Re: Response to Comments. Mine Plan Modification Dump C Expansion/Dump B Reduction. Lisbon Valley Mining Company LLC. 920 South County Road 313, La Sal, Utah, 84530.

The Lisbon Valley Mining Co LLC (LVMC) respectfully submits this response to the BLM's comments dated December 10, 2010. Our response is formatted as bullets in accordance with each comment received.

#### Diversion C4

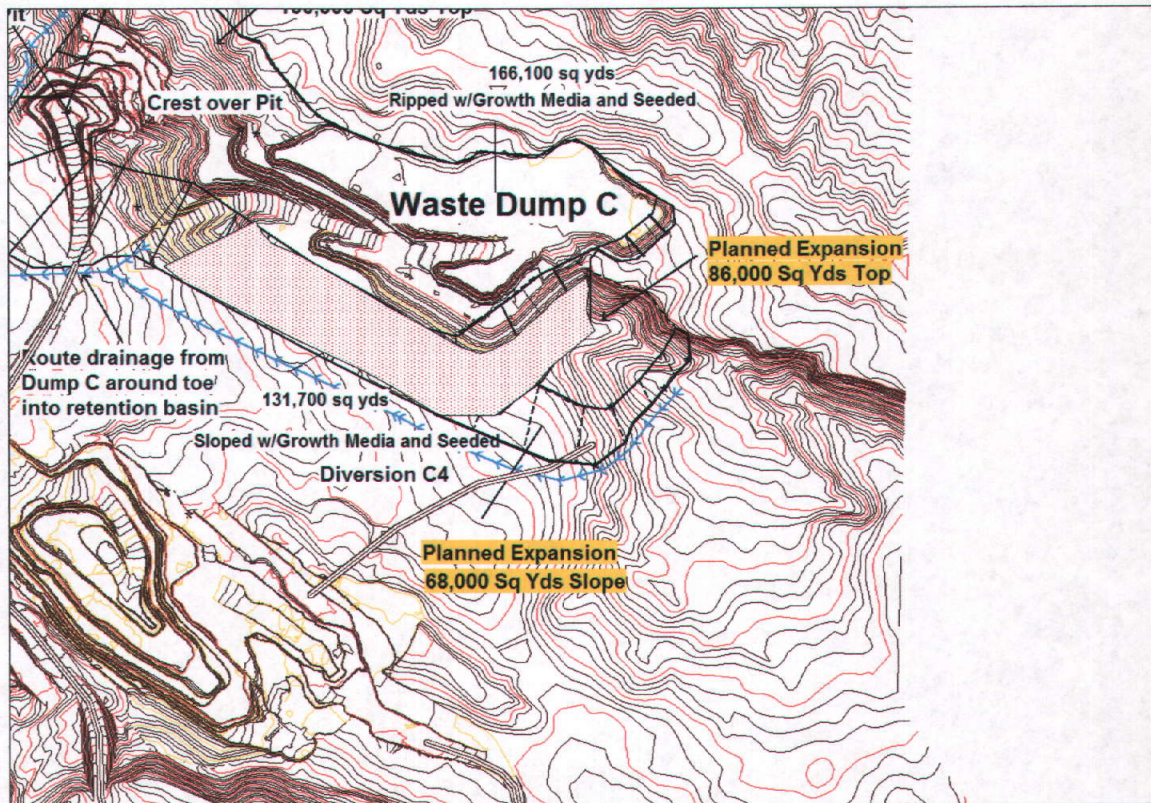
- The surface water diversion will be expanded to the south to route drainage from the east valley rim around the toe of the expanded slope (see Diversion C4).

- The haul distance from the center of the southern Centennial pit to the center of the proposed expansion is approximately 2150'. 750' of this distance will reach a 10% grade. The same haul to center of Dump B is 5150'. 1800' of this haul exceeds a 10% grade.
- Erosion control of the haul road is provided by the rock gradation (minus 24"). Similar rock is used as rip rap in diversion channels. Drainage will be routed around the toe of the slope to merge with Diversion C4. A rock-armored swale will facilitate drainage across the haul road.
